AGENDA
VENETA PLANNING COMMISSION
TUESDAY – MARCH 1, 2016 – 6:30 P.M.
Veneta Administrative Center, 88184 8th Street, Veneta, Oregon

**VENETA PLANNING COMMISSION'S
STAFF REPORT**

Yurtel, Bed & Breakfast – Track 2 Site Plan Review, City File #SR-5-15 – Track 2

**Yurtel Bed and Breakfast, Track 2 Site Plan Review,
City File #SR-5-15 – Track 2,
Assessor’s Map and Tax Lot No. 17-05-31-32-02300**

Designed by MASHORT	Checked by:	Approved by - date	Filename Yurtel-Site	Date 11/11/2015 - 1/11/2016	Scale 1/16"=1'
Mr. & Mrs. Jim Haddock 87991 Territorial Road Veneta, Oregon			SITE PLAN		
73U92015

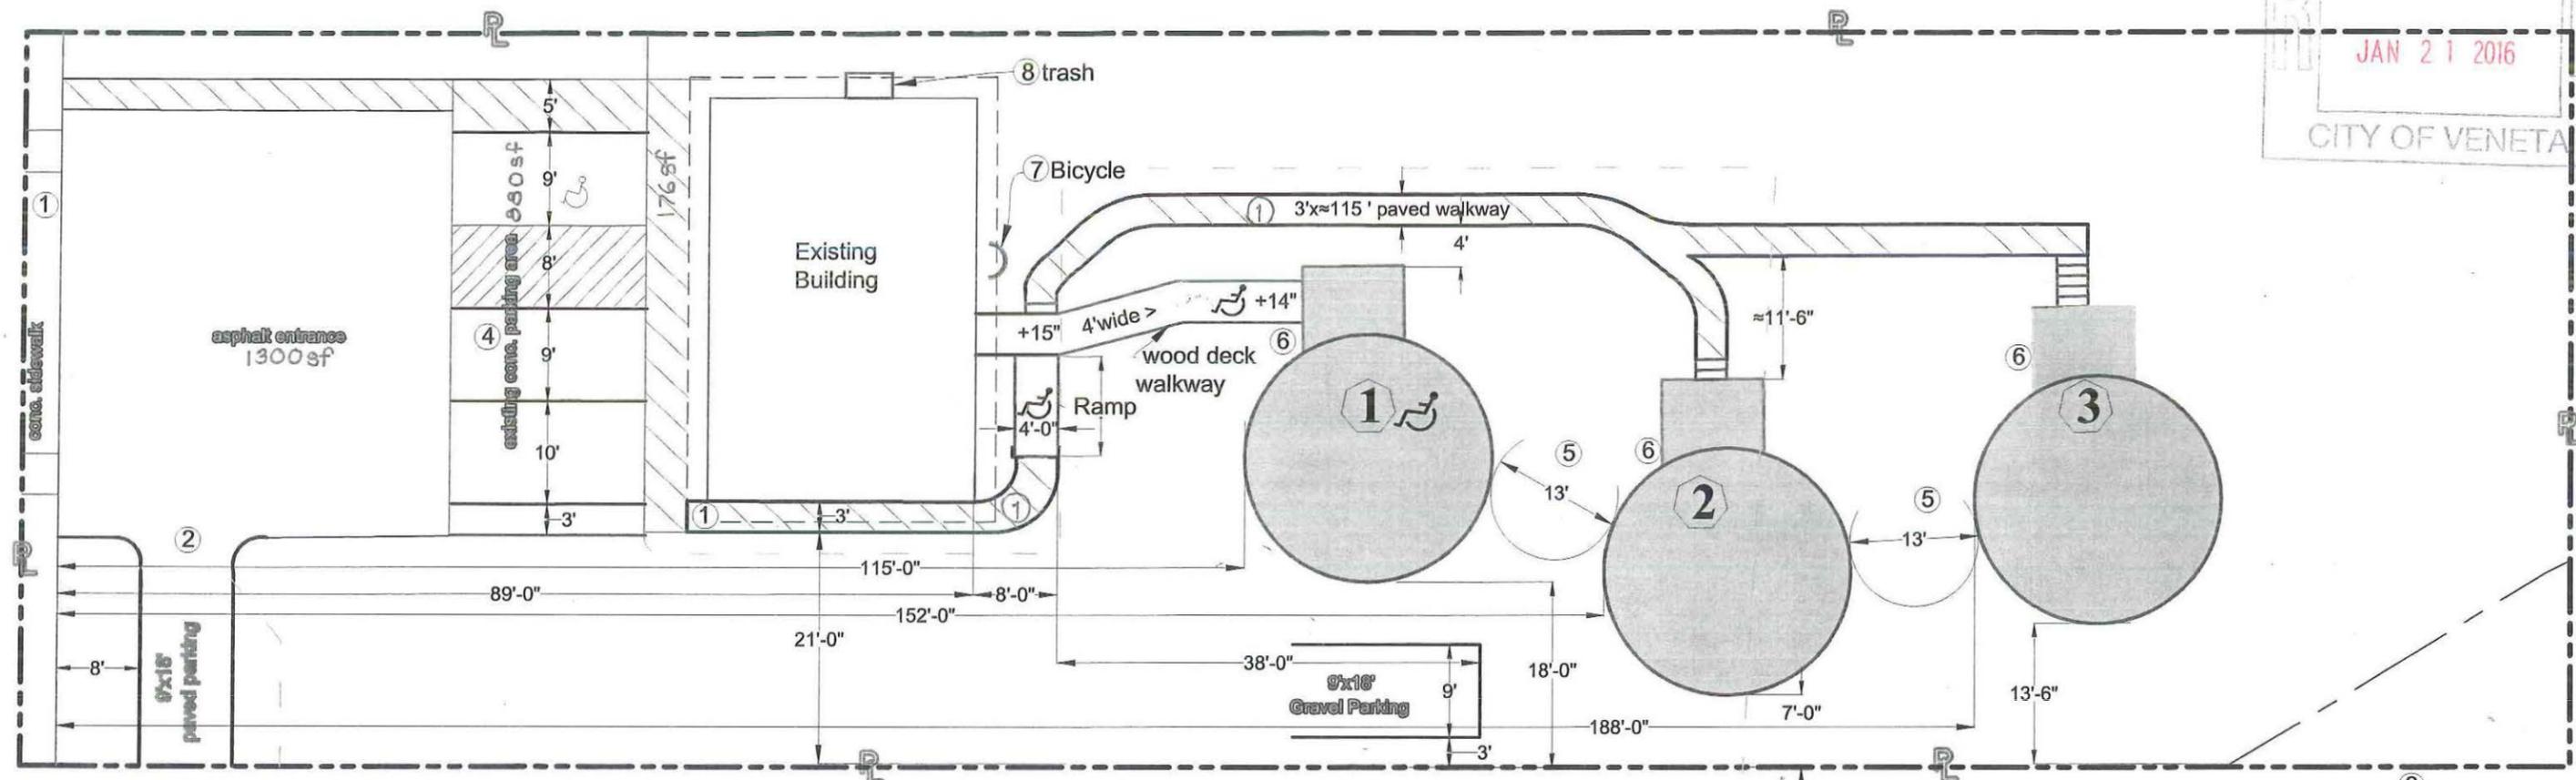
As conditioned, the proposal is consistent with this standard. The proposed Site Plan (Sheet A-2) indicates re-striping of the existing asphalt parking stalls in order to accommodate the van accessible aisle on the right side of the van accessible parking stall. An addition of one (1) new paved parking stall is proposed to be located abutting the south property line as shown on the Site Plan. Prior to final site plan approval, a minimum five (5) foot setback along the south property boundary for off-street parking areas in accordance with Veneta Land Development Ordinance No. 493, Section 4.06(5)(c) – Yards.

The proposal is consistent with this standard. The applicant is proposing to re-stripe the existing concrete parking area to the west of the existing building as depicted on the Site Plan (Sheet A-2). All parking spaces have a minimum dimension of eighteen (18) feet x nine (9) feet exclusive of maneuvering and access as proposed on the applicant's Site Plan.

The previous use (beauty salon) required two (2) parking spaces (City File# SR-3-14) but four (4) were provided. Veneta Land Development Ordinance No. 493 Table 5.20(1) requires one (1) space per guest room, plus one (1) additional space for the owner or manager. The applicant is proposing four (4) parking spaces including one (1) van accessible space as shown on the Site Plan (Sheet A-2) which meets this parking standard.

Designed by MASHORT	Checked by _____	Approved by - date _____	Filename ZURTELEXTLV	Date 11/9/2015	Scale 1/8"=1'
MR. & MRS. JIM, HADDOCK 87991 TERRITORIAL HWY VENETA, OREGON			EXTERIOR-ELEVATIONS		
			73U92015	Edition -	Sheet A-4

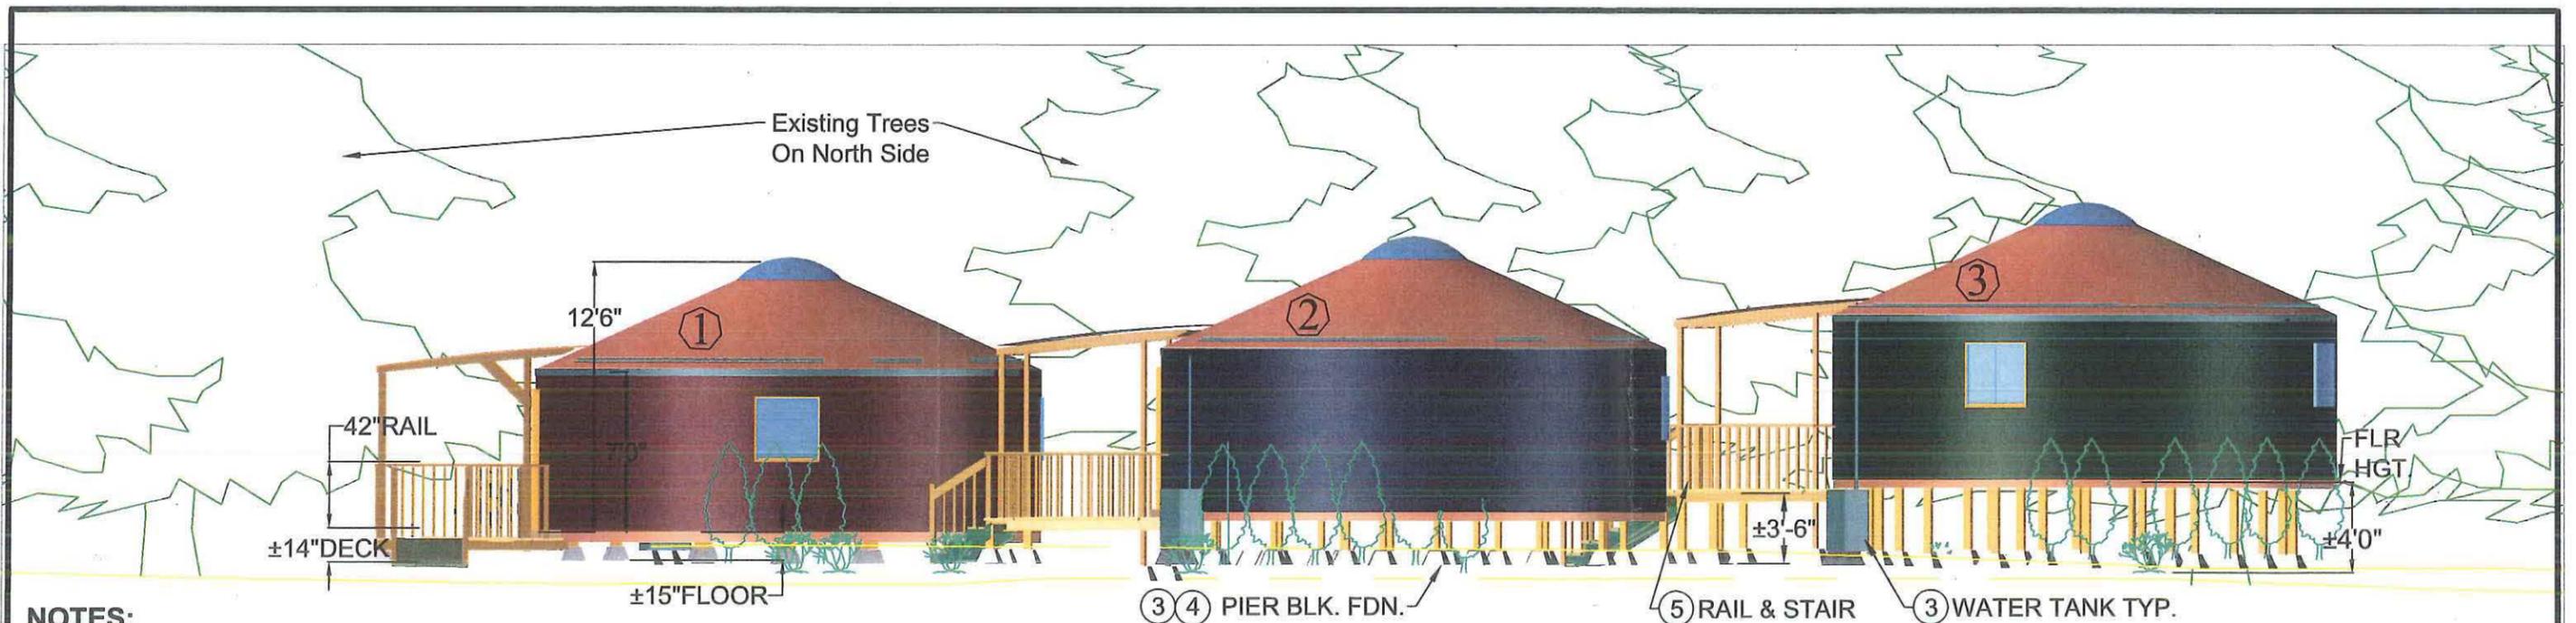
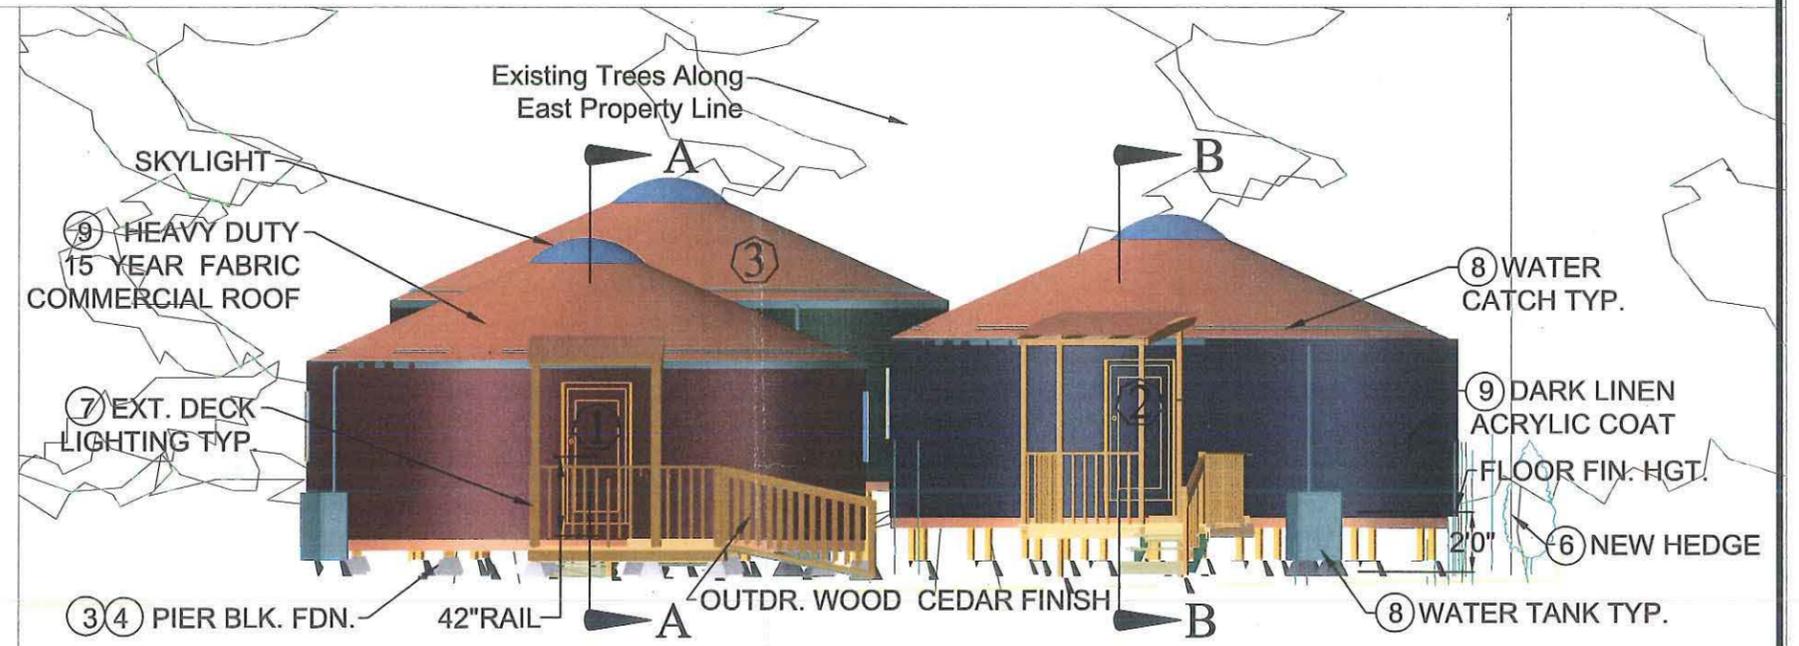
The proposal is consistent with this standard. The submitted exterior elevations (Sheet A-4) includes primary exterior materials which are consistent with the overall design composition and intent of typical yurt structure.

③ **Awning Detail** -N.T.S.

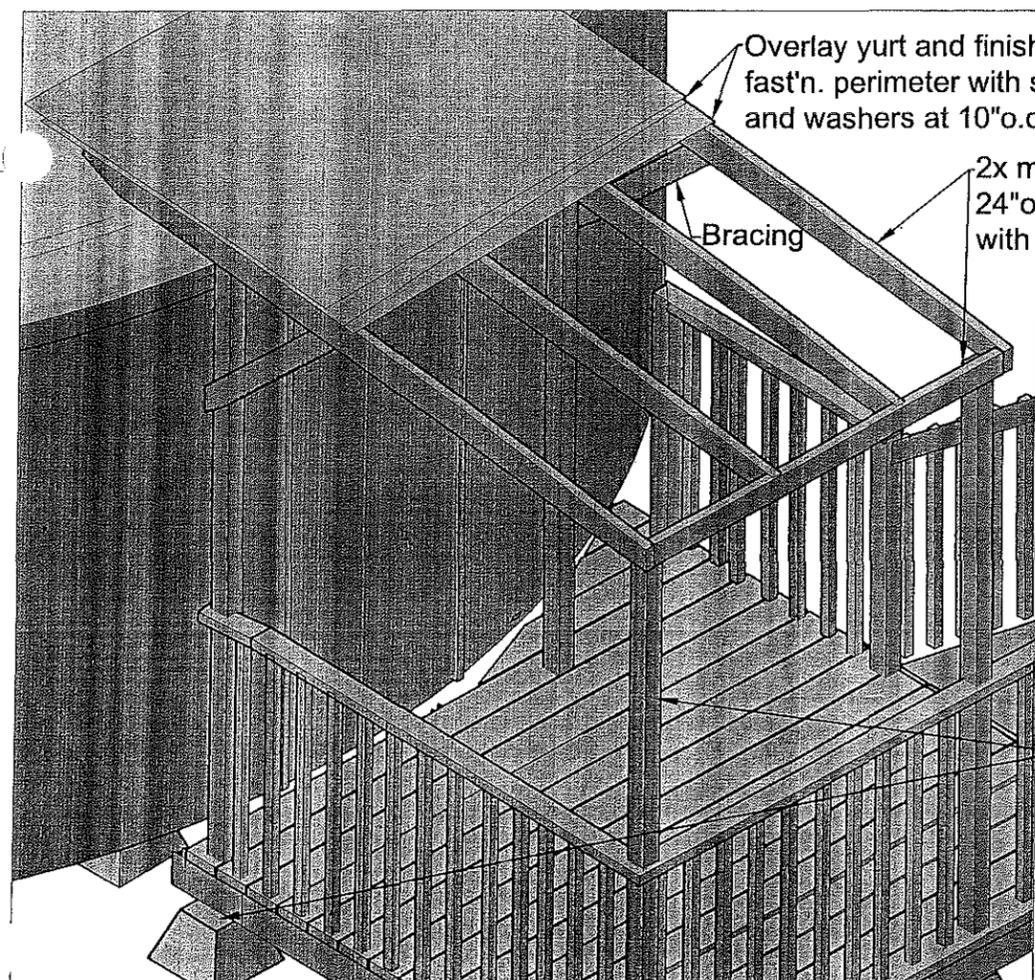
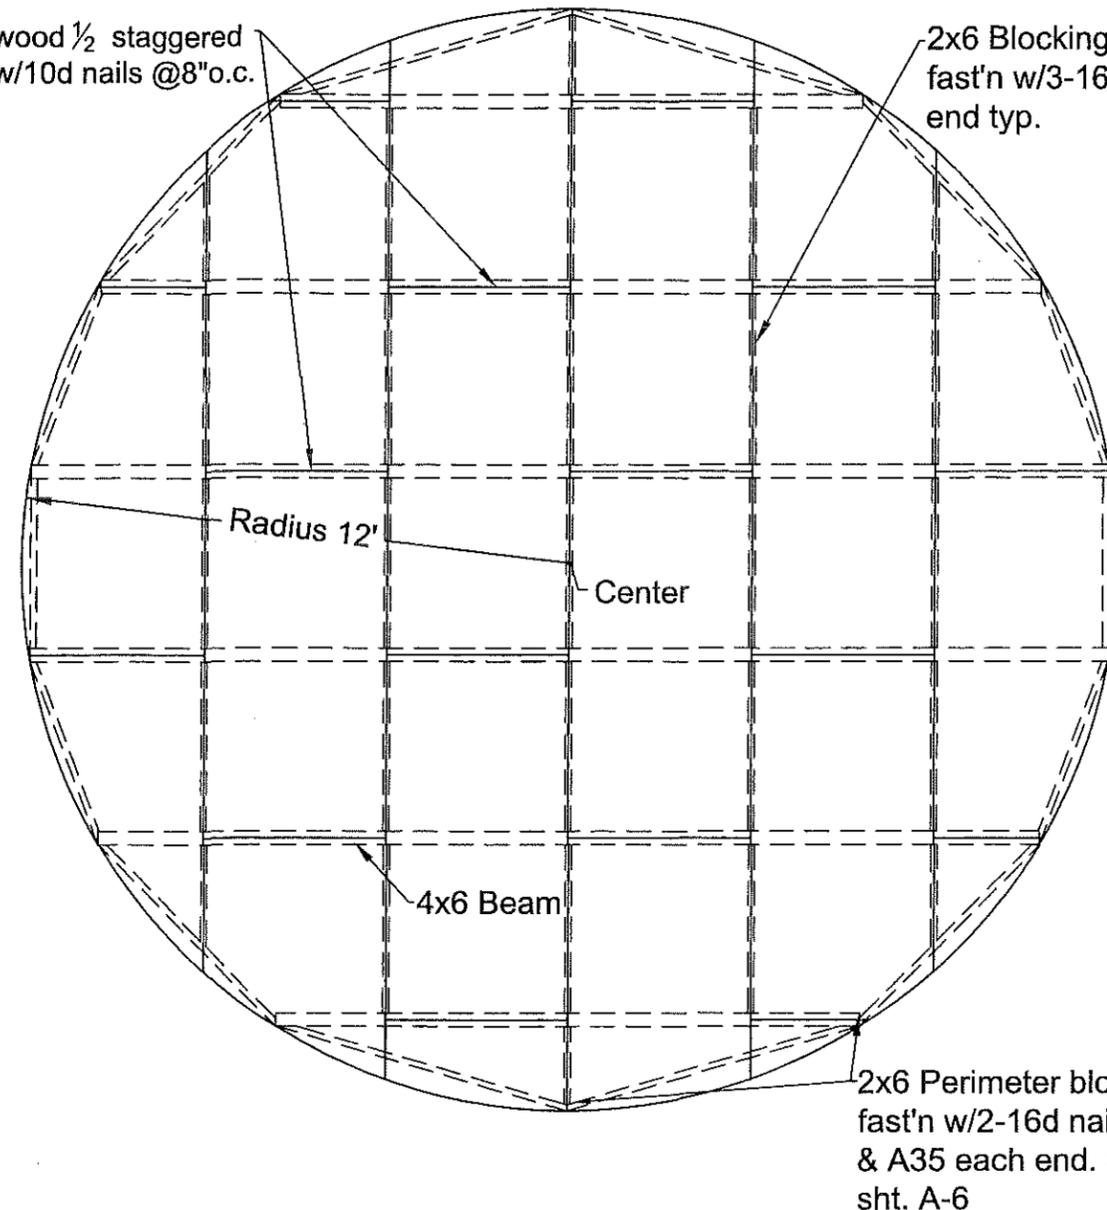
The proposal is consistent with this standard. The applicant provided proposed elevation, floor plans and details (Sheet A-3, A-4, A-7 and A-9) that shows each yurt structure will have an attached five (5) foot by six (6) foot door awning to act as a transition for a larger +/- six (6) foot by eight (8) foot awning which will provide adequate weather protection for guests.

Designed by MASHORT	Checked by	Approved by - date	Filename YURLAND	Date 11/24/2015	Scale 1/16"=1'
MR. & MRS. JIM, HADDOCK 87991 TERRITORIAL HWY VENETA, OREGON			LANDSCAPE		
			73U92015	Edition REV.A	Sheet A-10

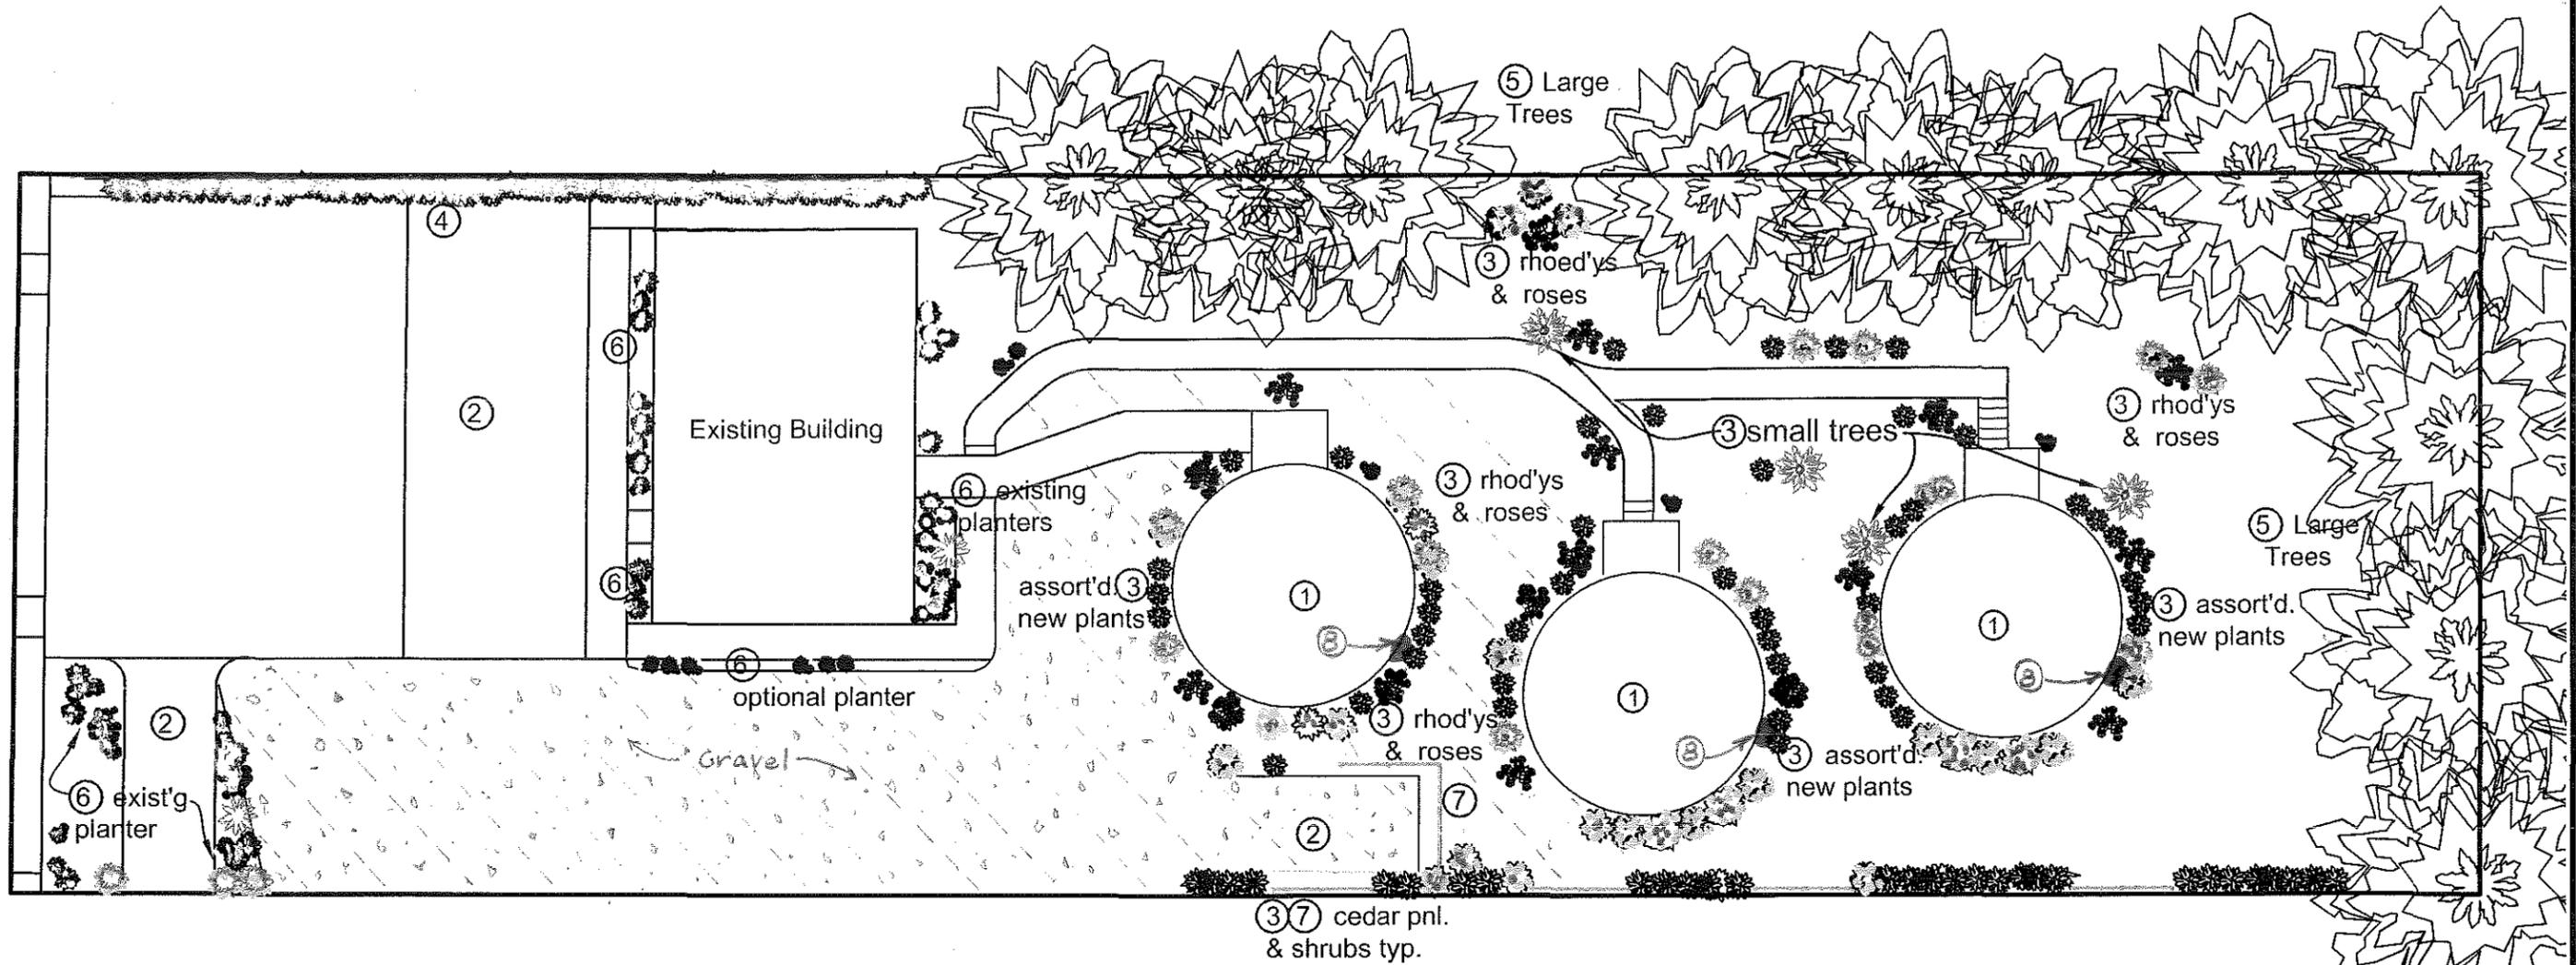
The proposal is consistent with this standard. The site is an approximate 0.43 acres or +/-18,730 square feet. Therefore, ten (10) percent of the site is equal to +/-1,873 square feet. The submitted Landscape Plan (Sheet A-10) shows existing and proposed landscaping is equal to 3,770 square feet (or +/-20%) of landscaping including; existing tree (+/-2,280 square feet), new plantings (+/-760 square feet), existing plantings (+/-730 square feet).
